Sedan Range

08.2-03

## **TECHNICAL BULLETIN**

Delayed Engagement –  
Powertrain 4L80-E Transmission –  
Revised Specification Transmission

ILLUSTRATION 1

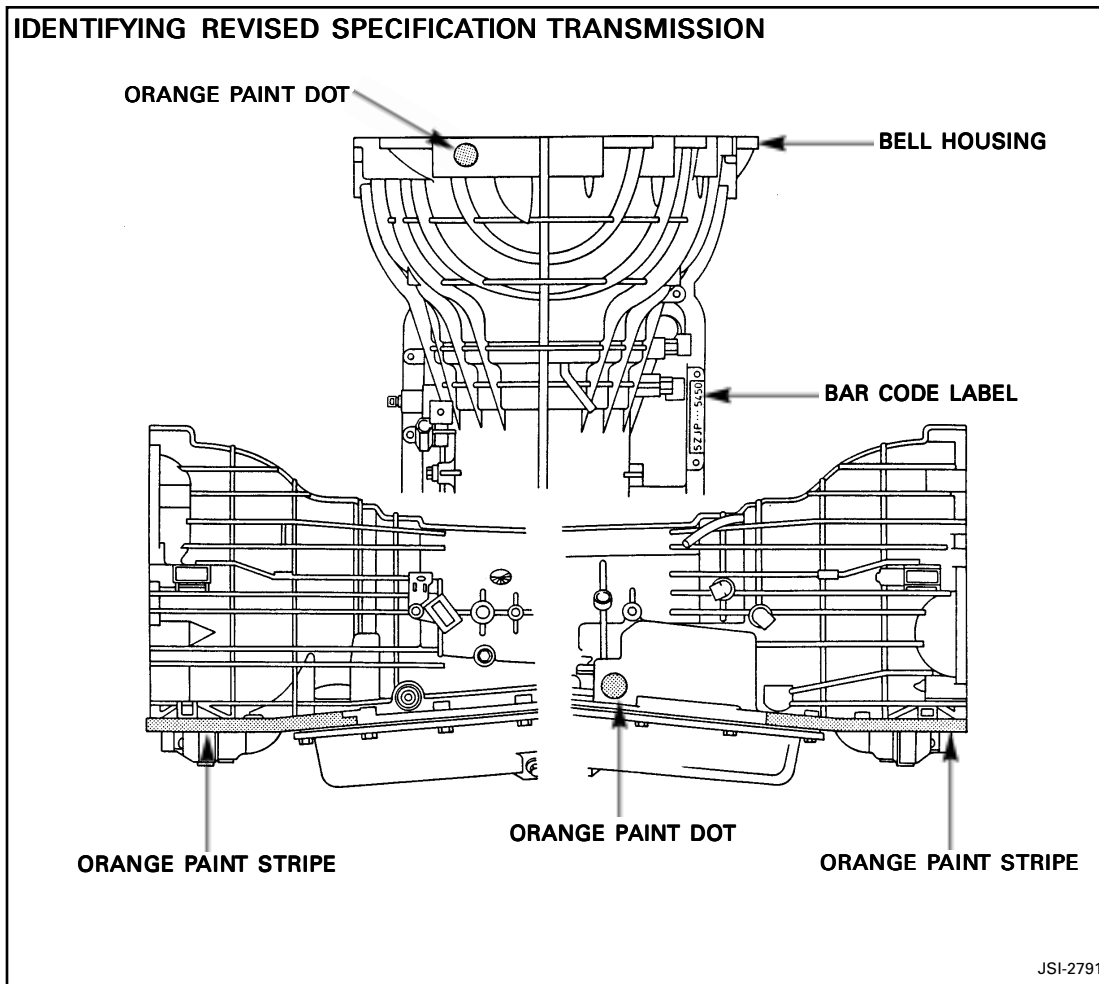
Transmissions with a serial number after 95ZJP5450 are the revised specification. Some transmissions with a lower serial number are the revised specification only if they are marked as shown in Illustration 1 on the following page.

Transmissions with serial no. before 95ZJP5450 with the following identification marks (Illustration 1):

- Orange paint dot, applied to the bell housing top, (not visible with transmission installed in vehicle).
- Bar code label on upper face of transmission case flange (visible by using mirror, with transmission installed in vehicle).
- Orange paint stripe at right side of the bell housing (on the continuation of the case flange).
- Orange paint dot, applied to the name plate surface on the right side of the transmission case.
- Orange paint stripe at left side of the bell housing (on the continuation of the case flange).
